ADDENDUM

Project: **Crestwood School District
Crestwood High School
Field Building & Site Improvements**

Date: **March 29, 2023**

Addendum Number: **#3**

6 Building B Elevation (West)
Scale: 1/4"=1'-0"

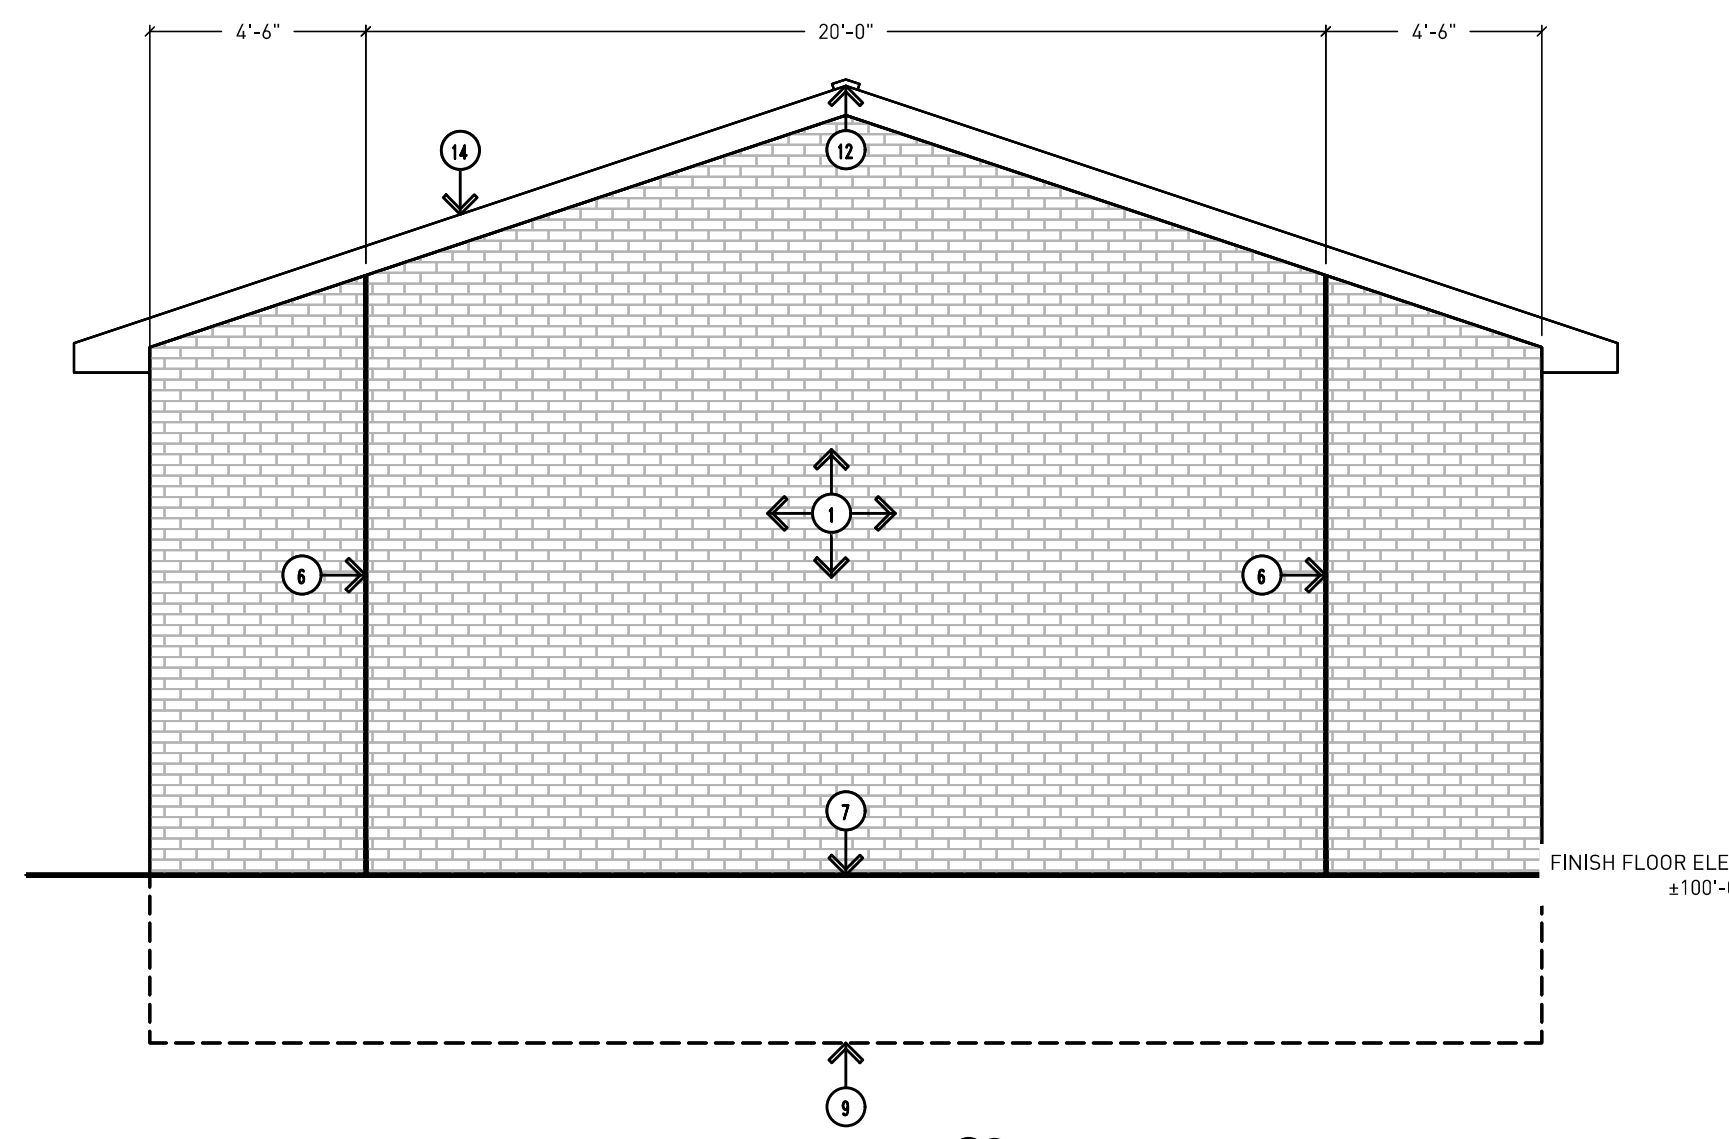
DELETE: Downspout on Detail 6/A3.01 Building B Elevation (West)

4 Building B Elevation (East)
Scale: 1/4"=1'-0"

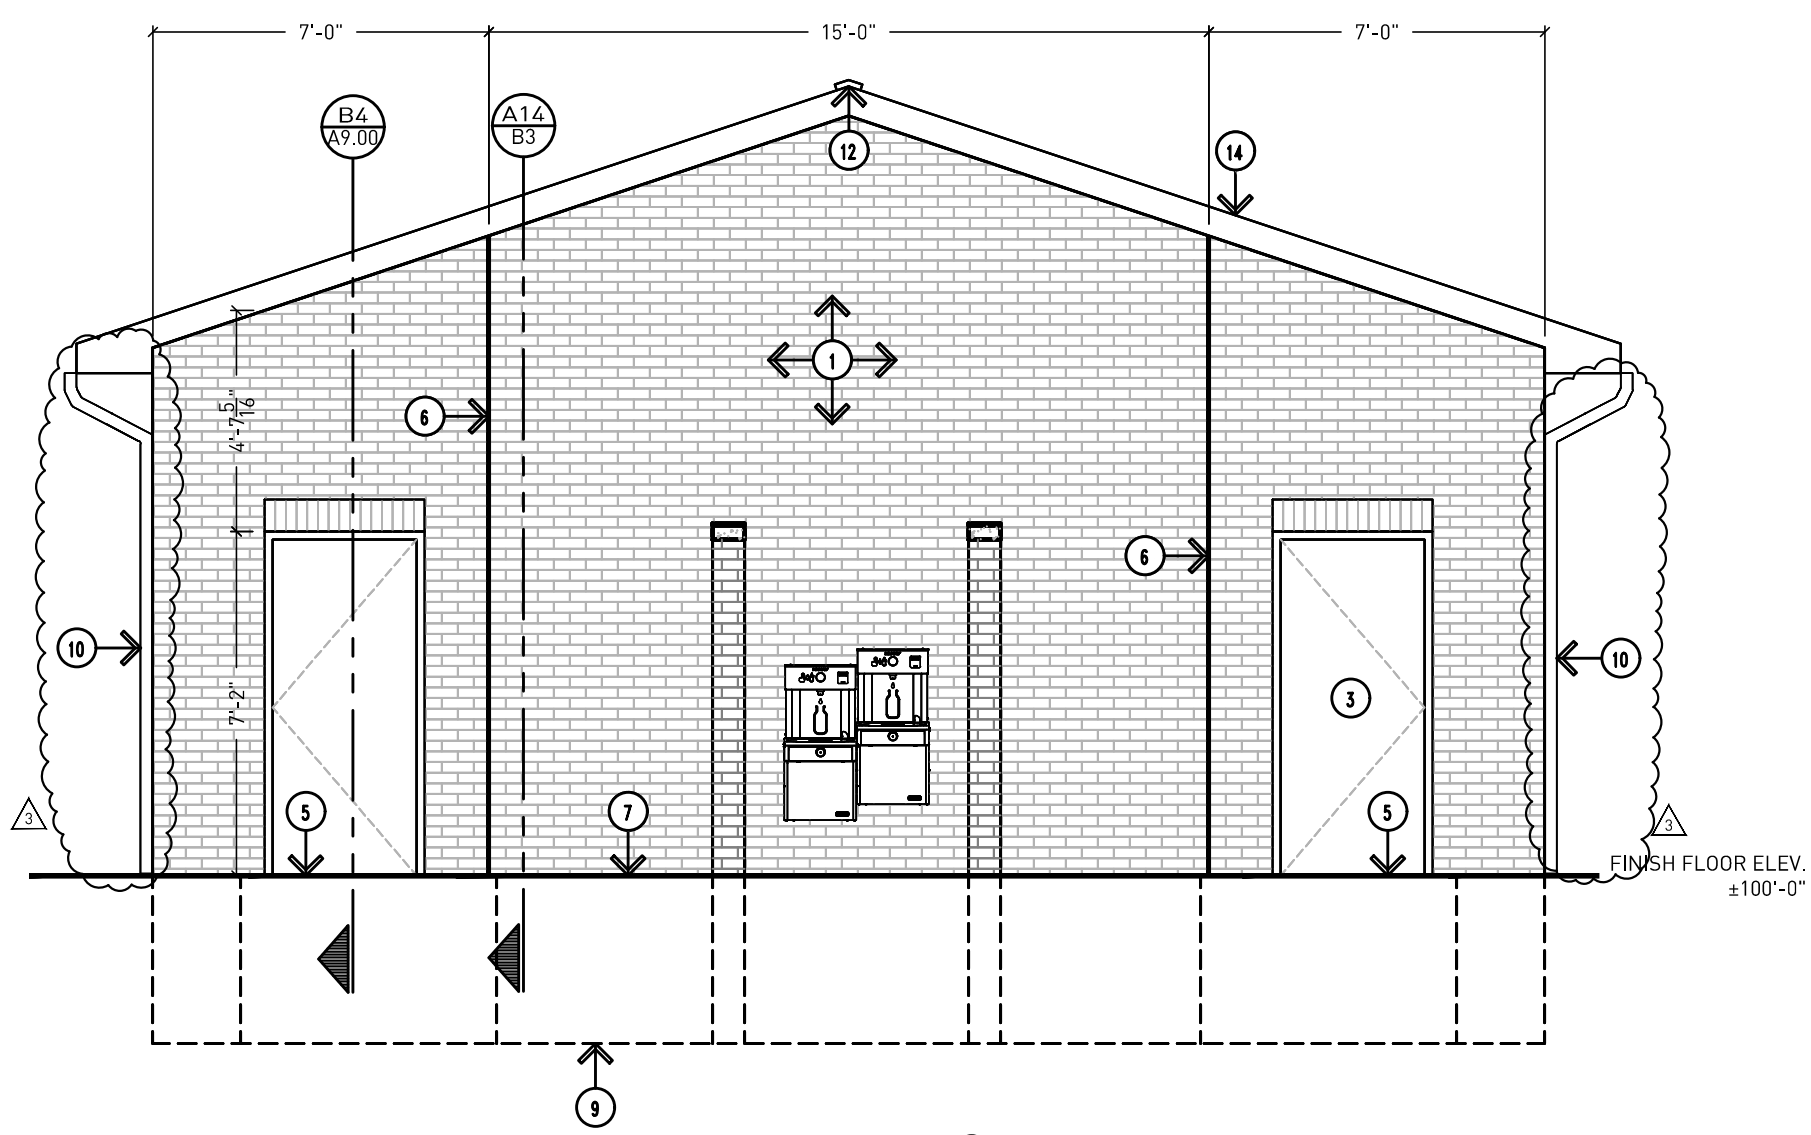
DELETE: Downspout on Detail 4/A3.01 Building B Elevation (East)

3 Building B Elevation (North)
Scale: 1/4"=1'-0"

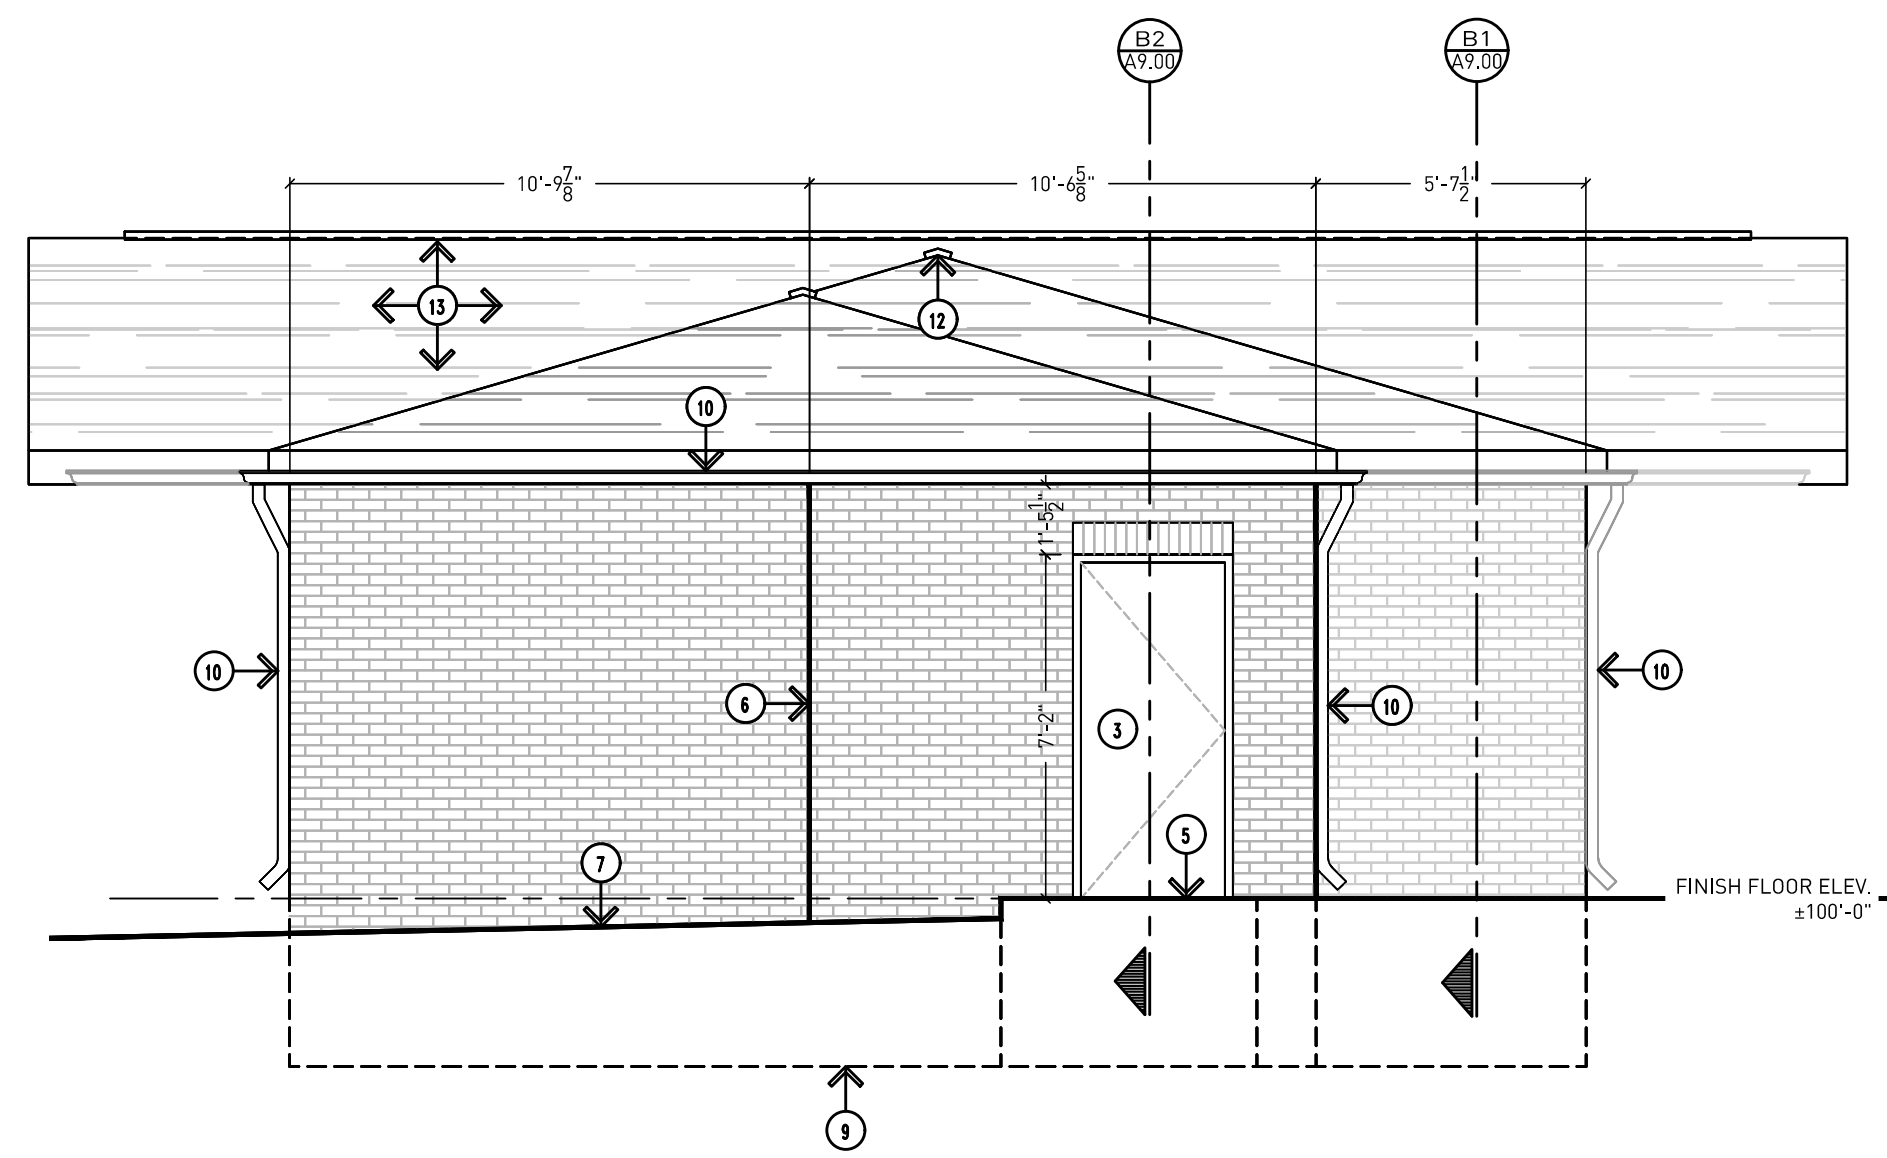
ADD: Downspouts on Detail 3/A3.01 Building B Elevation (North)

A10 Building A: Area 1 Exterior Wall Section
A9.00
 Scale: 1"=1'-0"

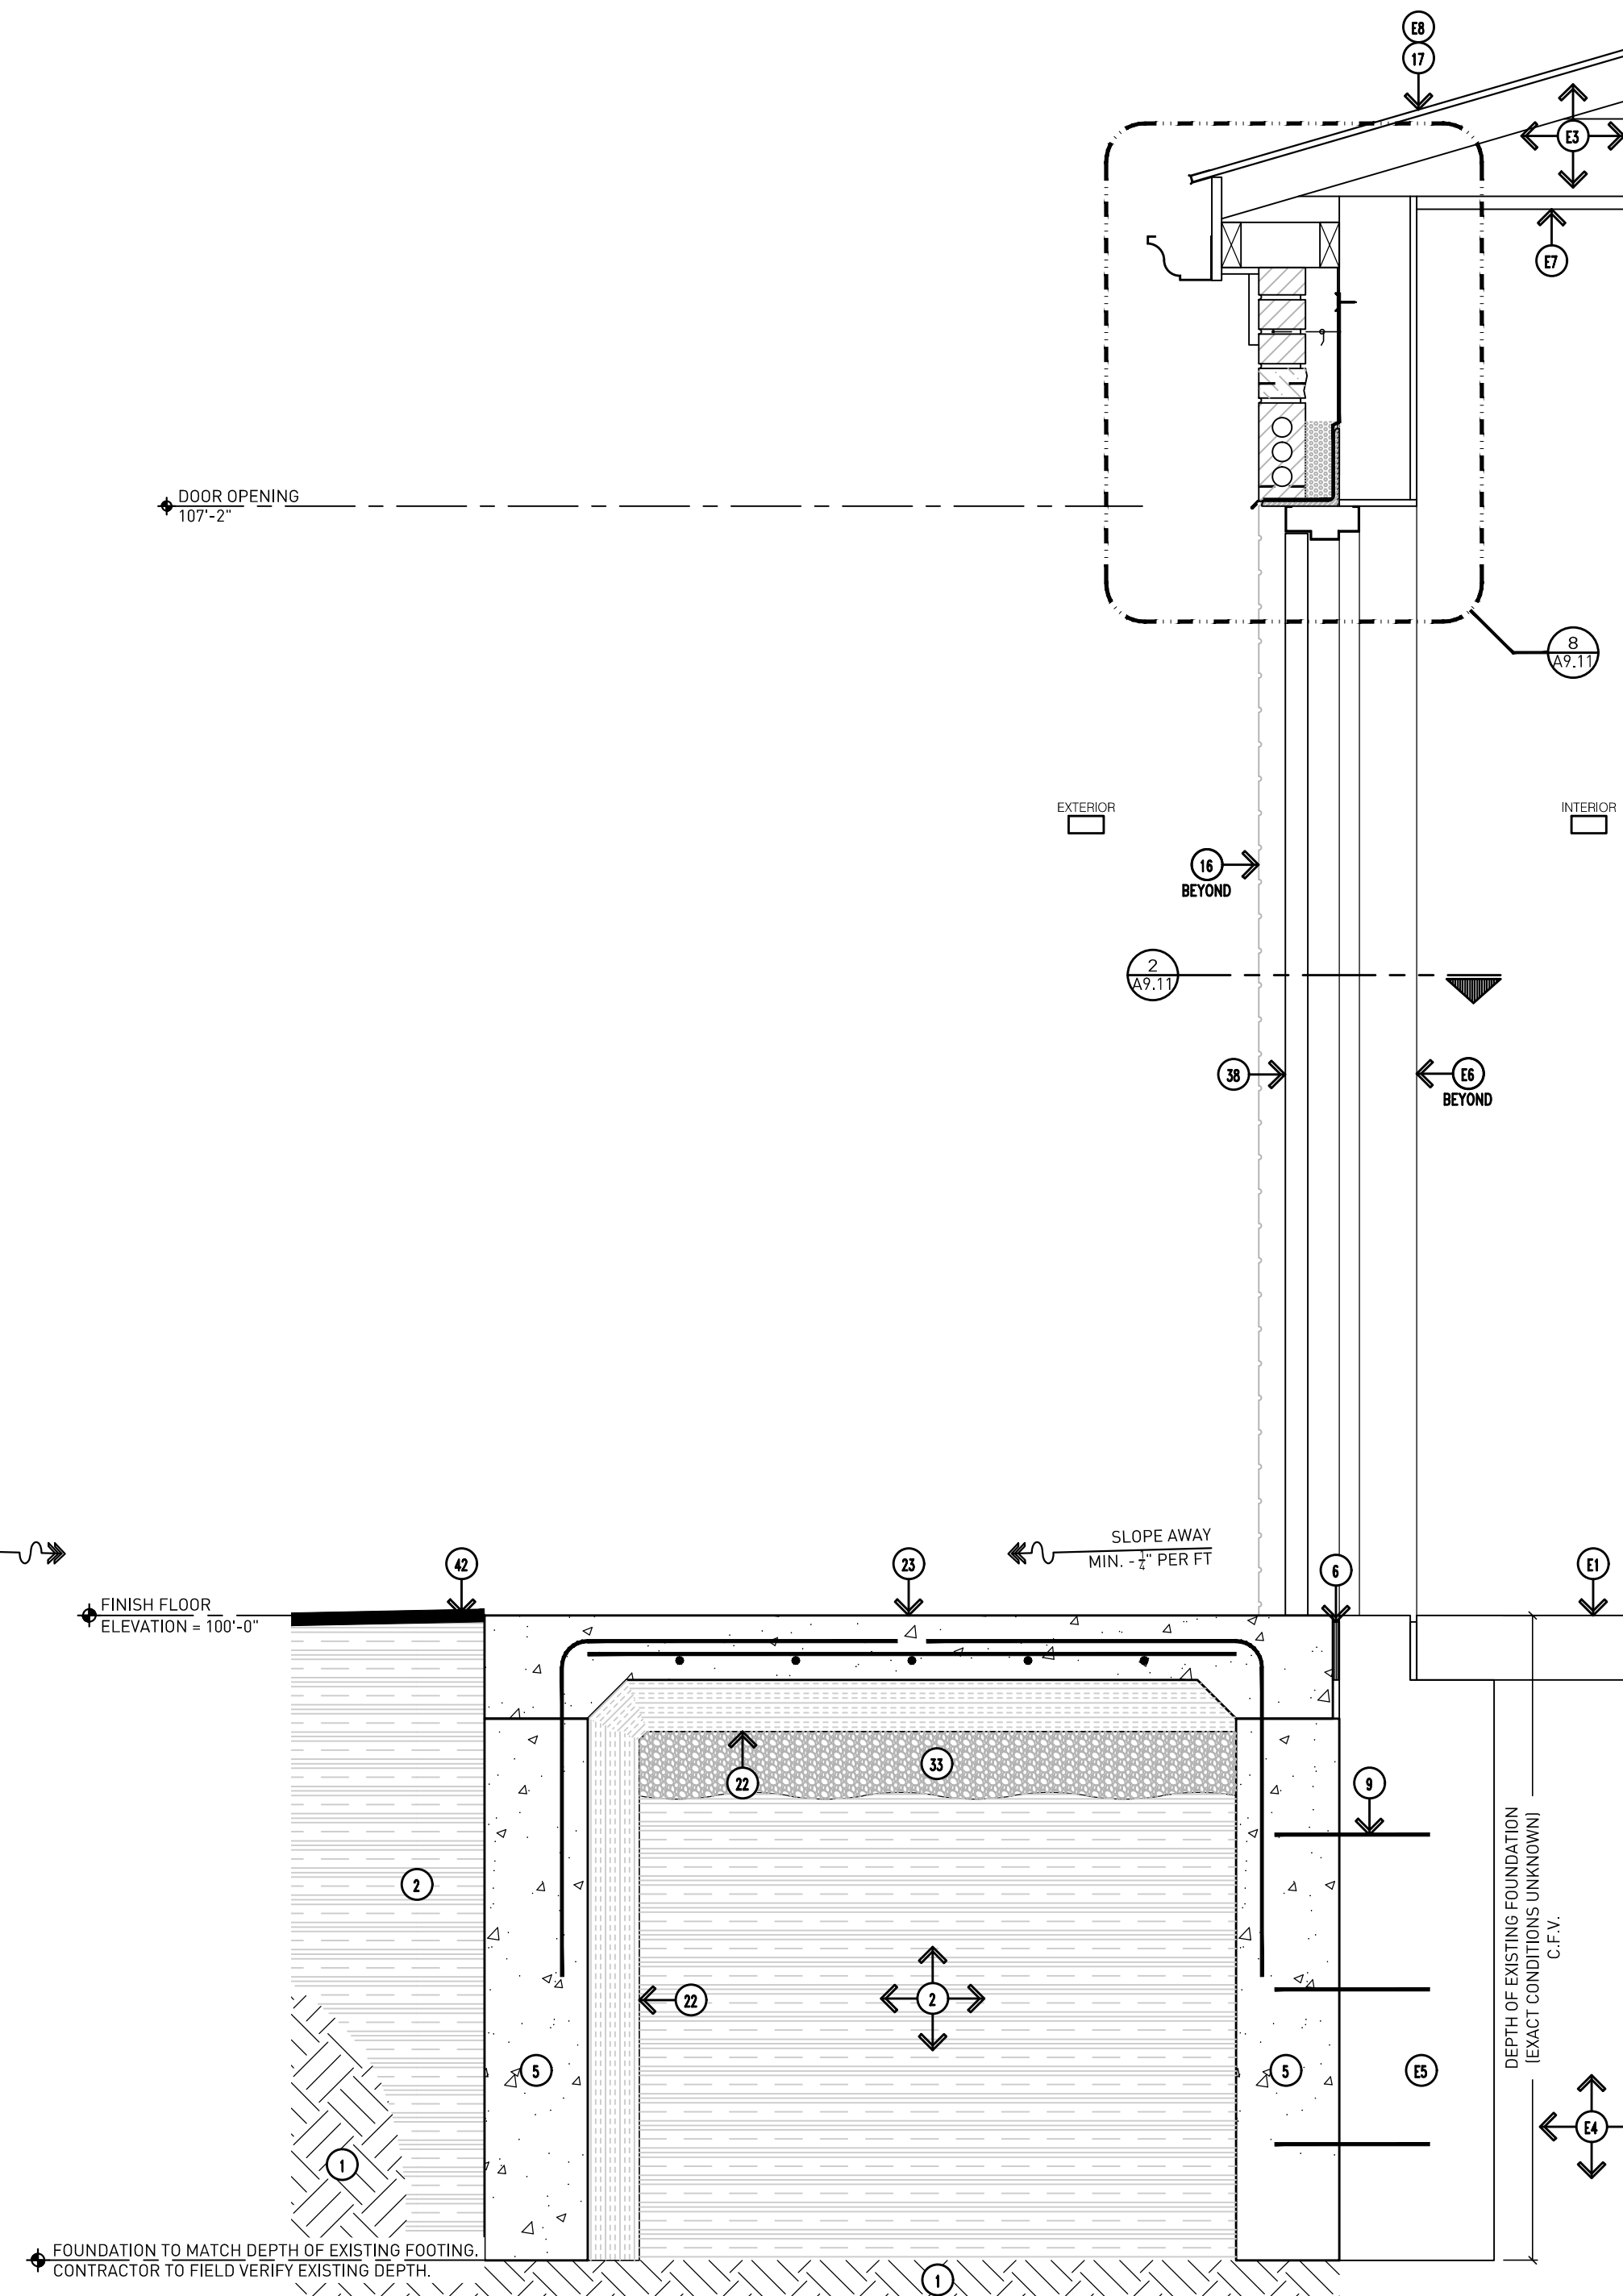
CHANGE: Note 26
FROM: 2"x 8" preservative treated wood plate.
TO: 2"x 6" preservative treated wood plate.

REVISE: Detail A10/A9.00 as indicated on sheet.
